**RE: McCumber Hill Pit, File No. M-2000-151, Technical Revision (TR-2), Adequacy Review #2**

## McCumber Hill Pit M2000-151 TR2 Adequacy Review

# EXHIBIT C, PRE-MINE AND MINE PLAN MAP FOR THE MCCUMBER HILL PIT- A SAND, GRAVEL AND ROCK OPERATION

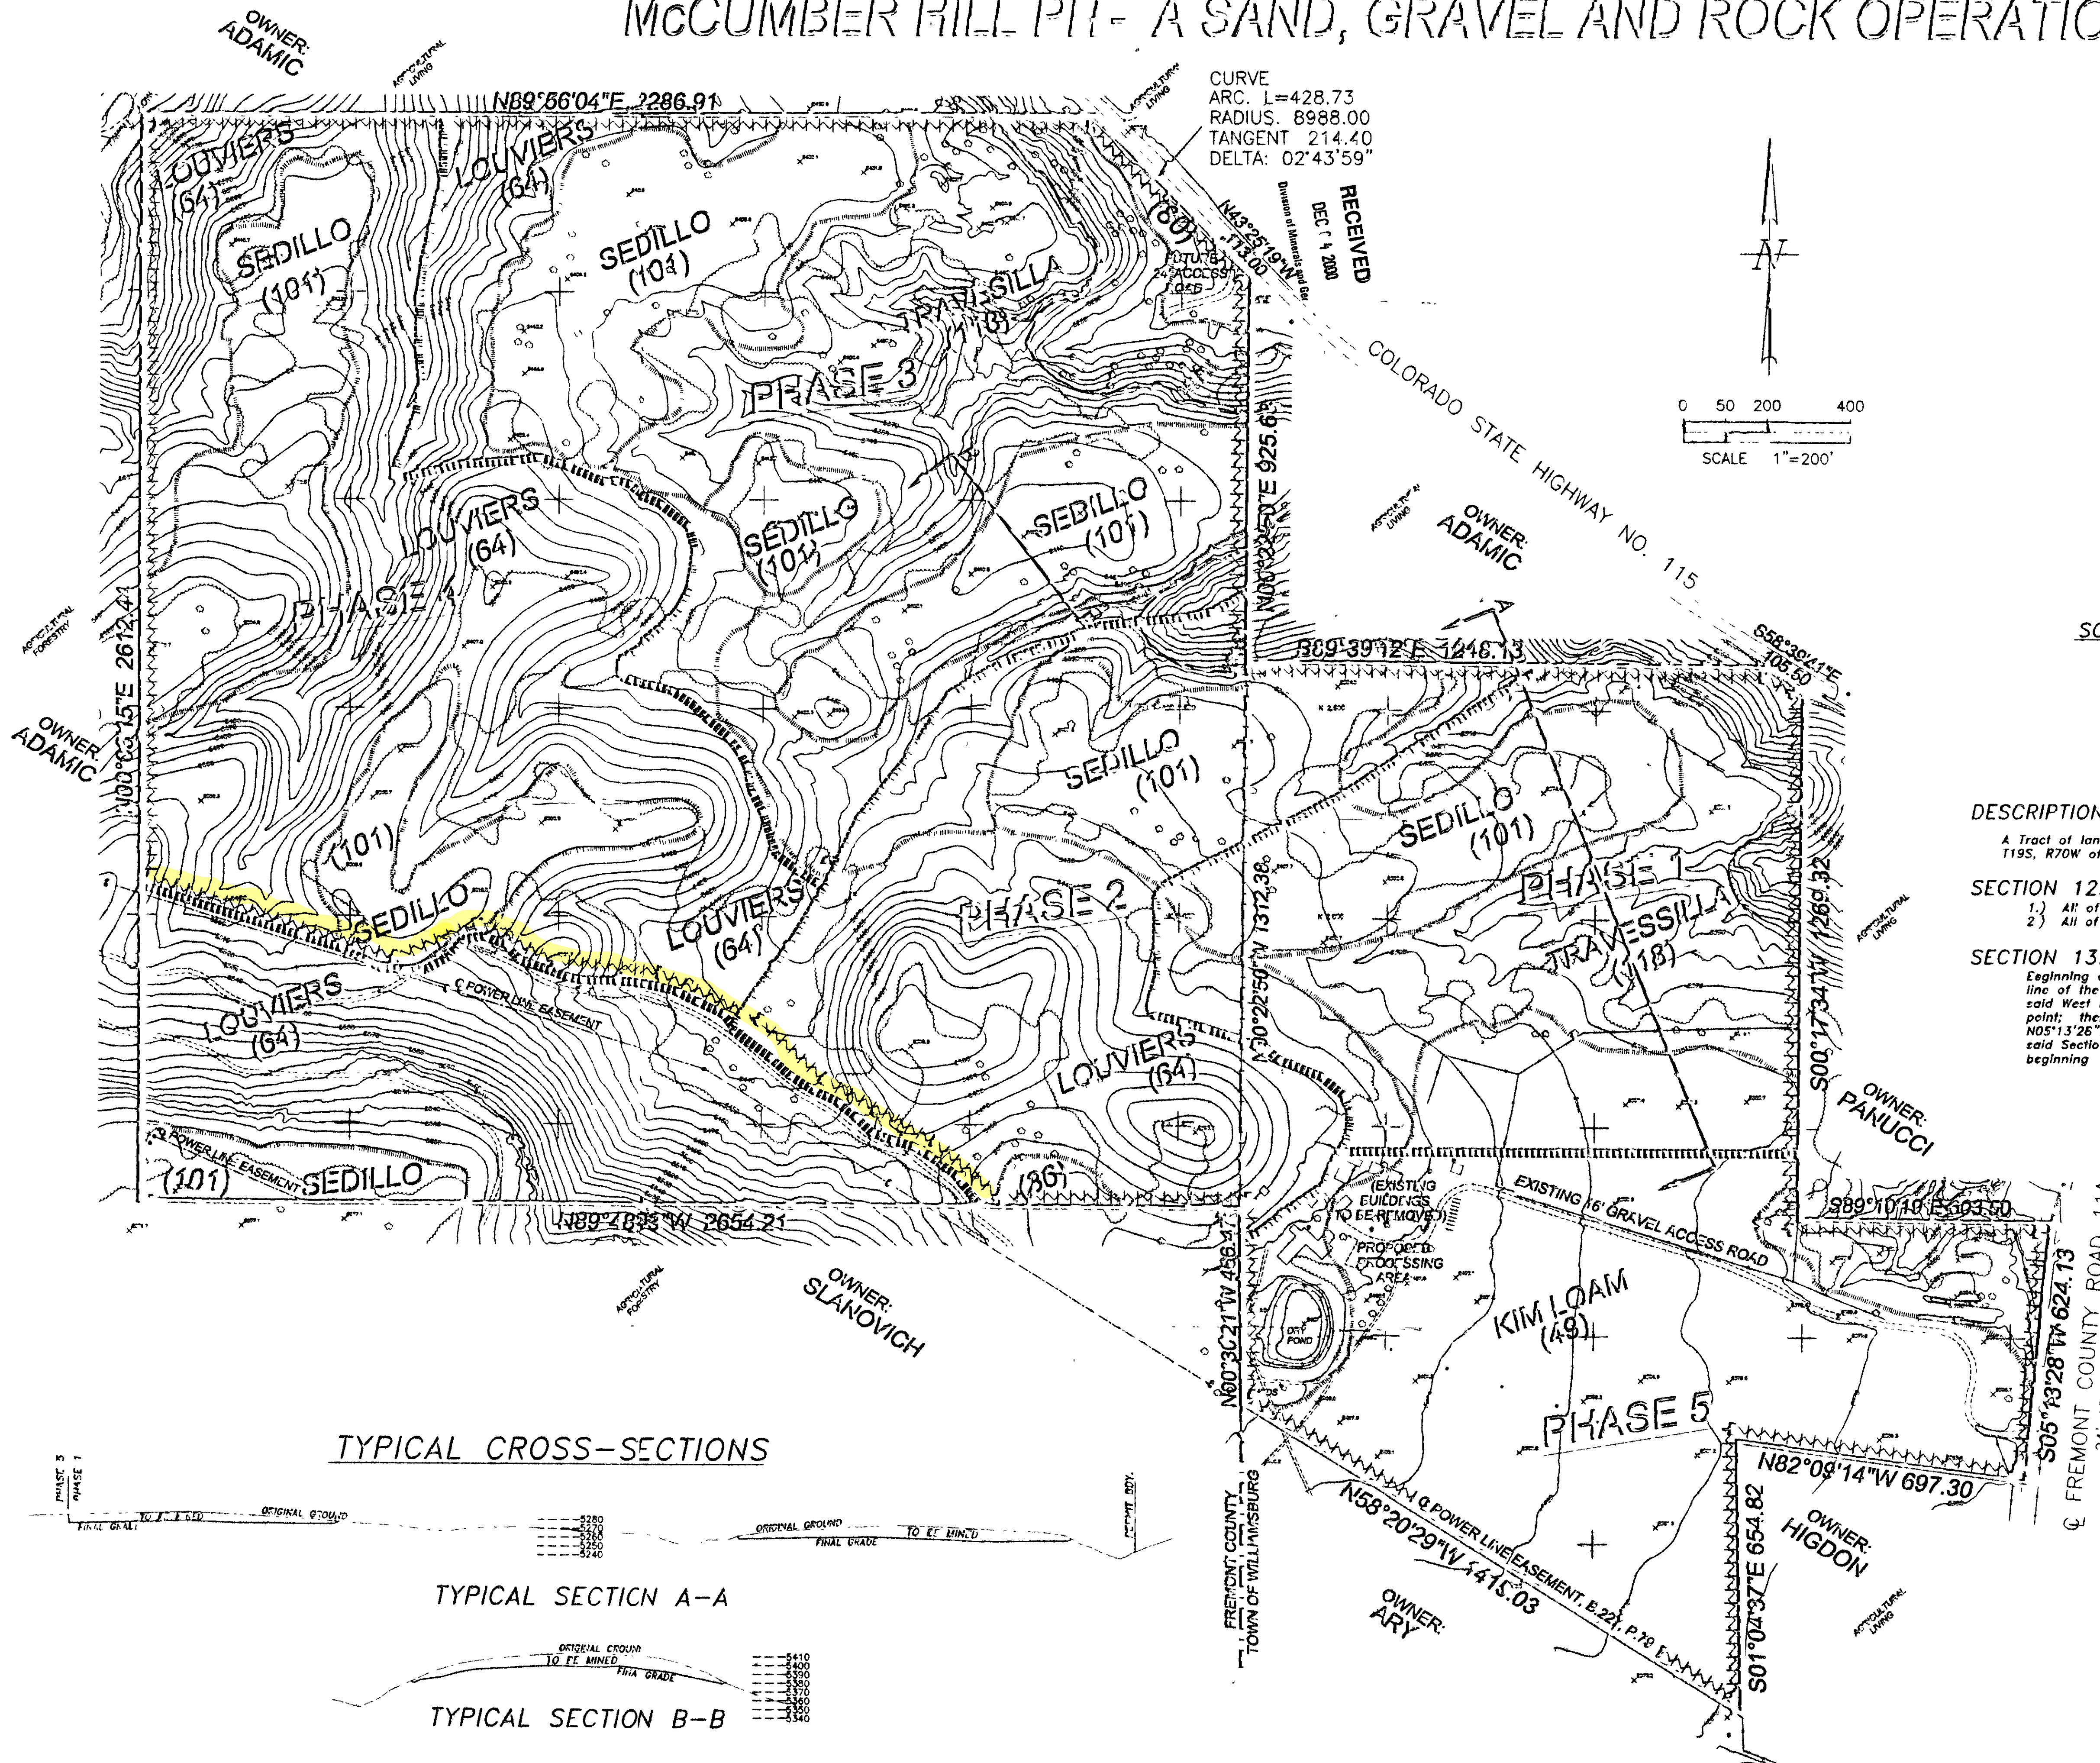
1. The Division acknowledges the Operator's emailed clarification of Item No. 3 in the original adequacy letter (attached). Exhibit A of the permit application states that the legal description covers "the land to be affected by the planned operation". This legal description covers all of the 231.12 acres permitted. However, Exhibits C and F maps are misleading in that the phased boundary and affected area boundary lines on these maps seem to suggest that not all of the permitted area is considered affected area (maps attached). Please update these maps to more clearly show that the affected acreage boundary aligns with the permit boundary.

We checked the legal description, and it matches the permit boundary. Since there is no secondary boundary listed or any details given on the map or in the narrative of any offset or the distance of such, we stand that the permit boundary and the affected area boundary are the same. The phase boundary that you highlighted is a completely different boundary within the permit and again doesn't delineate any decrease in affected or permitted area but is a section of such.
